CORRESPONDENCE FOLLOWING CIBP SET @ 3260 WITH SUBSEQUENT  
PRESSURE OBSERVED ON CASING - APPROVED CHANGES TO  
P&A PROCEDURES.

ATTACHMENT TO 2/17/2010 EMAIL

Knight 12-5

05-045-06832

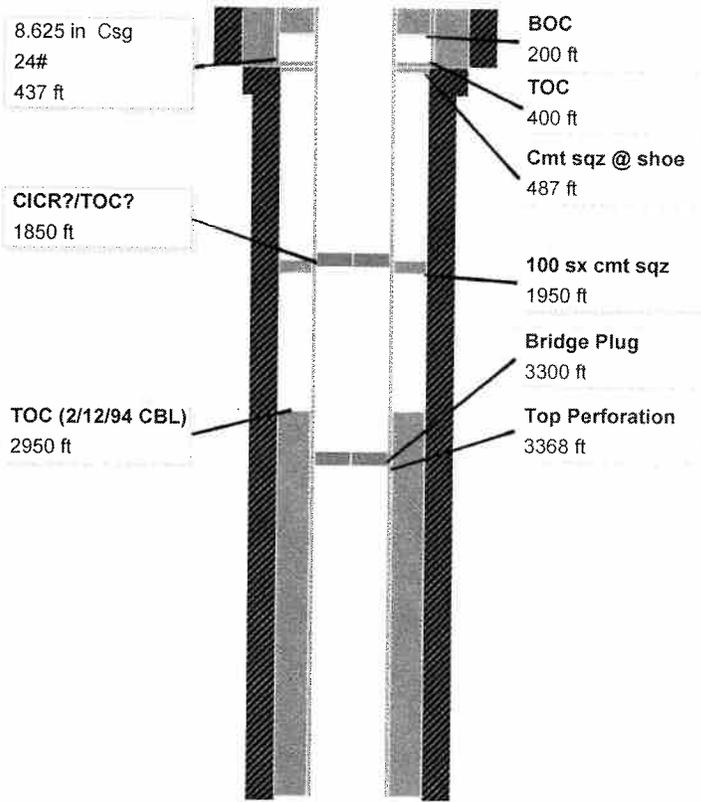
The attached file summarizes my current understanding of the wellbore configuration. I discussed this well with Dave Dillon again. We are still concerned about possibly compromising surface casing integrity if EnCana perforates the production casing at 400'. With cement above and below 400' in the surface casing-production casing annulus, it may be difficult to squeeze off holes at 400' when final plugs are

Bradenhead is venting. Likely Wasatch gas. First attempt to squeeze off gas was 100 sx cmt at 1950'. This attempt was either unsuccessful, or source of gas is above 1950'. Gas possibly migrating through channels or around cement squeeze from 487' to 400' with surface casing shoe at 437'. Cement is also present in surface casing-production casing annulus from 200' to surface.

Wellbore detail not shown below a depth of 3368' (top perforation)

set. At best, we may only be able to pump cement in the production casing across the holes. If the source of the gas is not completely shut off, this may force gas out of the surface casing after the well is plugged.

We understand that EnCana would like to expedite the bleed off and final P&A of this well. We would prefer to see production casing perforations somewhere between 1950' and 487'. Following the bleed off, EnCana could then perforate additional holes in this interval and attempt a suicide squeeze between the two sets of perforations. Cement plugs would also be required in the production casing from 500' to 400' and 50' to surface.
